TOWN AND COUNTRY PLANNING ACT 1990
APPEAL UNDER SECTION 78

FINAL COMMENTS / REBUTTAL

Site	Dolphin Court, Shelley Road, Worthing, West Sussex, BN11 4DD
Proposal	Mansard-type roof extension to provide 4 no. additional residential units (Class C3)
LPA reference	AWDM/1103/25
PINS reference	6007549
Decision	Refusal, dated 5 November 2025
Prepared by	CMK Planning on behalf of the Appellant
Date	02 June 2026

Figure 1 — The appeal site within its immediate context (base imagery: Google Earth). Storey heights as recorded in the Council's officer delegated report.

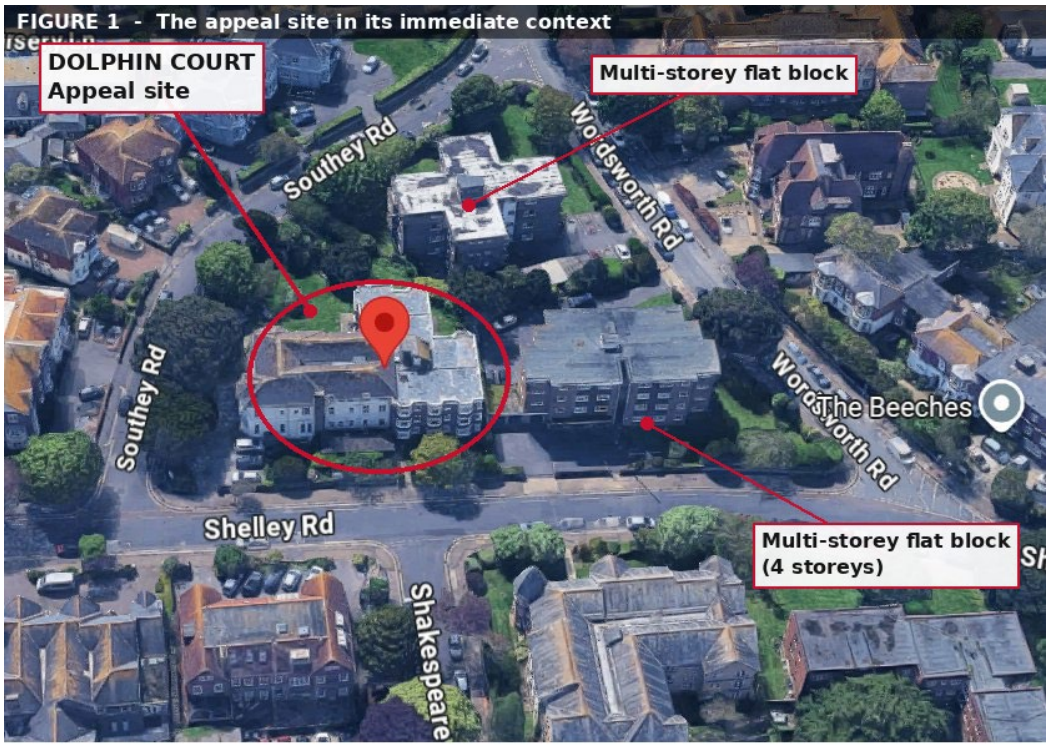
2.1 The Council's Statement asserts that the surrounding area is "typically 2-storey" and that, "for the most part, roofs are pitched". Neither characterisation withstands scrutiny when the immediate context of the site is examined — which is where any assessment of scale, dominance and roof form must begin. The immediate context is formed by three buildings: the appeal building itself, Hopedene Court and Queen's Mansions. There is no two-storey building amongst them. On the Council's own officer delegated report, the host is a 2½-storey villa; the element to which the proposal is actually applied is the existing three-storey flat-roofed addition; and the immediate neighbours, Hopedene Court and Queen's Mansions, are each four storeys. The officer report describes the area as comprising "purpose-built and converted flat buildings and several large residential / nursing care home buildings" — not two-storey villas. The aerial view at Figure 1 confirms that the site sits within a tight group of large, multi-storey flatted blocks. Any attempt to characterise this context as "2-storey" is simply incorrect.

2.2 This is not a peripheral matter. Reason 1 — "dominance", loss of "subordination", an "unduly assertive" form, harm to character — is an exercise in *relative* scale. If the context against which the proposal is judged is mis-described, the conclusions drawn from it cannot be relied upon. Measured

against a two-storey villa townscape, *any* additional storey will read as excessive; that is precisely the conclusion the Statement reaches. But it is a conclusion produced by the incorrect premise, not by the proposal. Corrected to the true three- to four-storey flatted context, the assessment changes entirely: a single additional storey, contained within a mansard, on a building already three storeys high and set amongst four-storey blocks, is an appropriate addition. The same error of method affects the roof-form point: whilst pitched roofs may predominate in the *wider* streets, the immediate context — the host addition itself and the adjacent blocks — is substantially flat-roofed. The Council cannot make a sound assessment of scale, dominance or roof form on a description of the area that is contradicted by its own evidence.
